Product Change Notification

Product Group: OPT/Tuesday September 1, 2026/PCN-OPT-1495-2026-REV-0

IL41x, BRT2x, VO41xx, VO306x OptoTRIACs green production line transfer

DIP-6

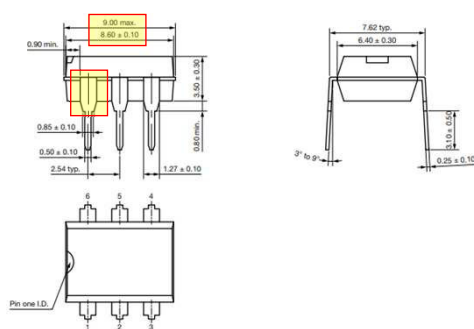
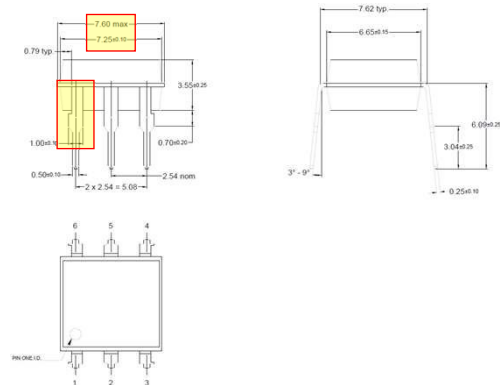
Note: major changes are the package length and the lead shape form

DIP-6, 400 mil (option 6)

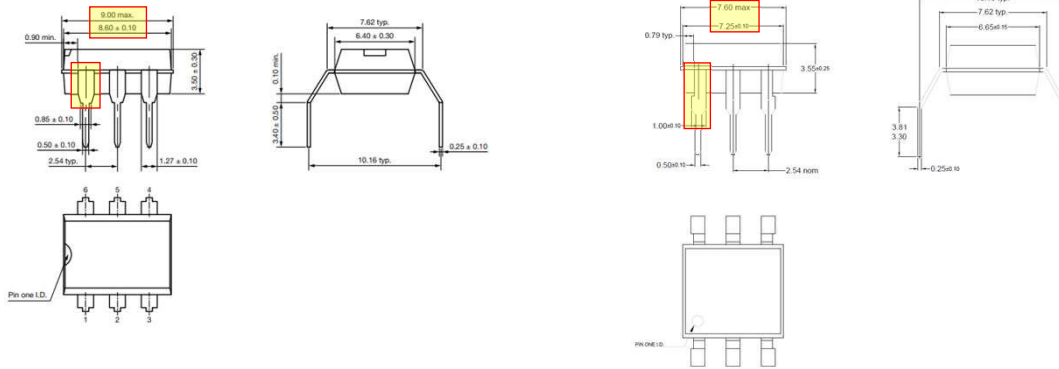
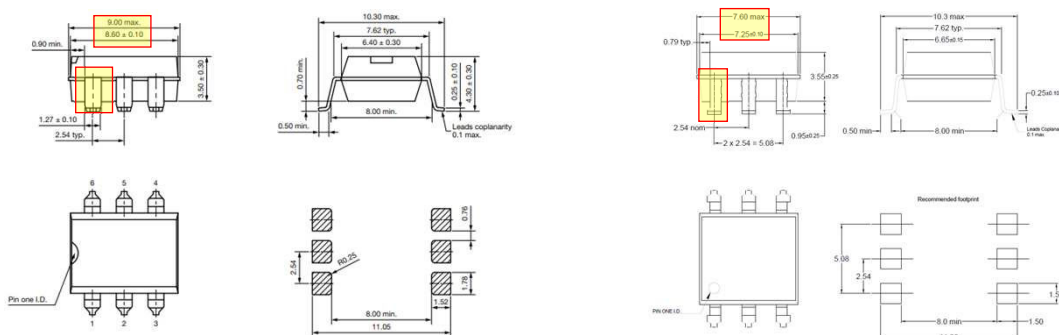
Note: major changes are the package length and the lead shape form

SMD-6 (option 7)

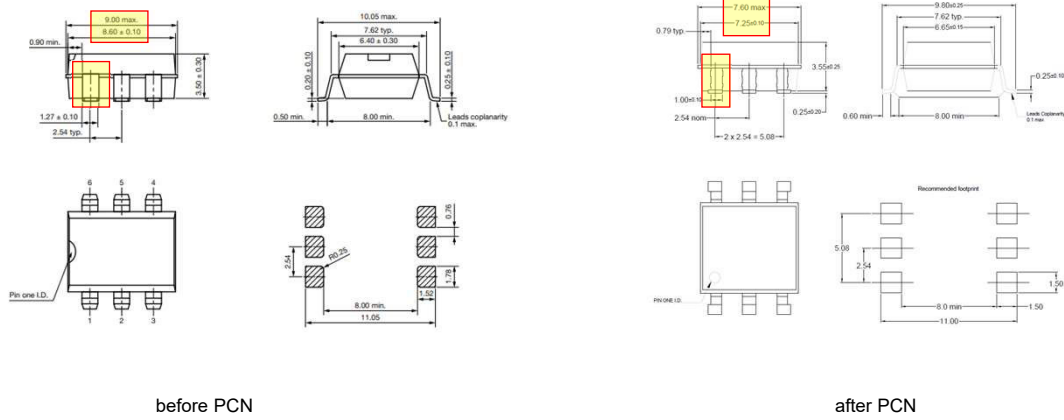
Note: major changes are the package length and the lead shape form
